**[Docket No. 2000-SW-15-AD; Amendment 39-12175; AD 2001-07-09]**

**Airworthiness Directives; MD Helicopters Inc. Model MD-900 Helicopters**

**2001-07-09 MD HELICOPTERS INC:** Amendment 39-12175. Docket No. 2000-SW-15-AD.  
Supersedes Emergency AD 99-26-20, Docket No. 99-SW-89-AD.

**Applicability:** Model MD-900 helicopters, with main rotor upper hub (hub) assembly, part number (P/N) 900R2101006-105 or 900R2101006-107, installed, certificated in any category.

**Figure 1. Main Rotor Upper Hub Assembly Inspection.**

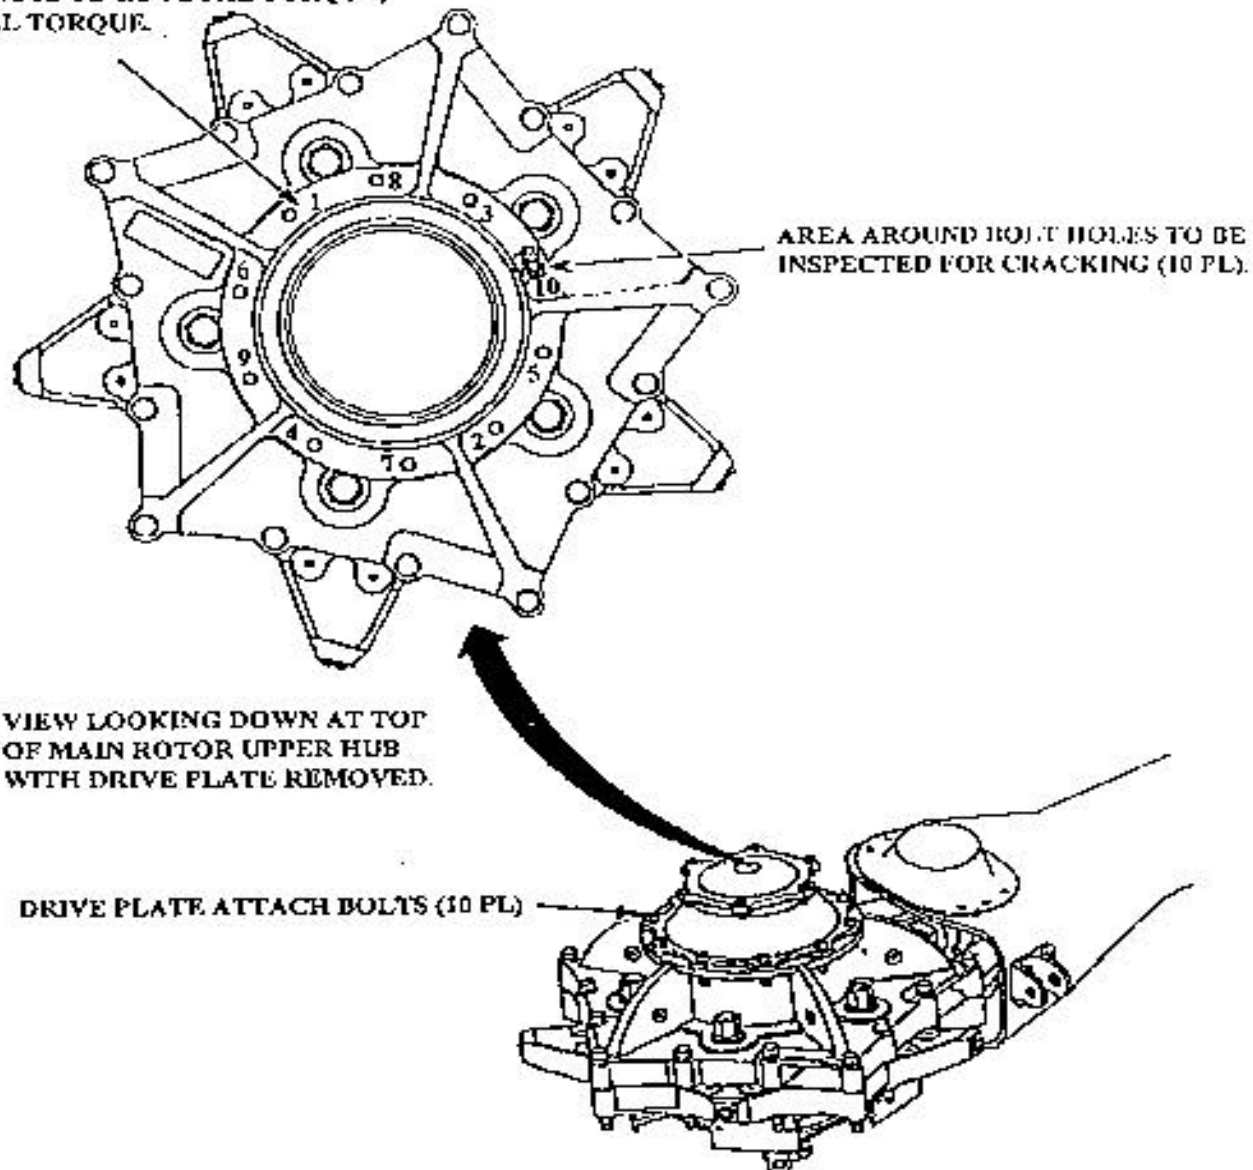
- (i) If present, remove sealant from the drive plate attachment to the hub assembly.
- (ii) Mark the main rotor hub holes, bolts, and nuts to correspond with the drive plate hole numbers (see Figure 1).

- (v) Using paint stripper (Consumable Item List C313 or equivalent) and cleaning solvent (C420 or equivalent), remove the paint from the upper mating surface of the hub assembly to enable an accurate visual inspection of the drive plate attachment bolt hole (bolt hole) area for cracking (Figure 1). Ensure the paint stripper and solvent DO NOT contaminate the upper bearing and upper grease seal areas.

- (viii) Reinstall the main rotor drive plate using 10 new sets of replacement attachment hardware. Torque the nuts to 160 inch pounds above locknut locking/run-on torque in the sequence shown (Figure 1). Record in the rotorcraft logbook, or equivalent record, the locknut locking/run-on torque for each nut.

1. MAIN ROTOR DRIVE PLATE ATTACHMENT  
HARDWARE TORQUE SEQUENCE.
2. NUMBERING MAY START AT ANY HOLE.
3. TORQUE NUTS TO 1/2 TOTAL TORQUE,  
THEN FULL TORQUE.
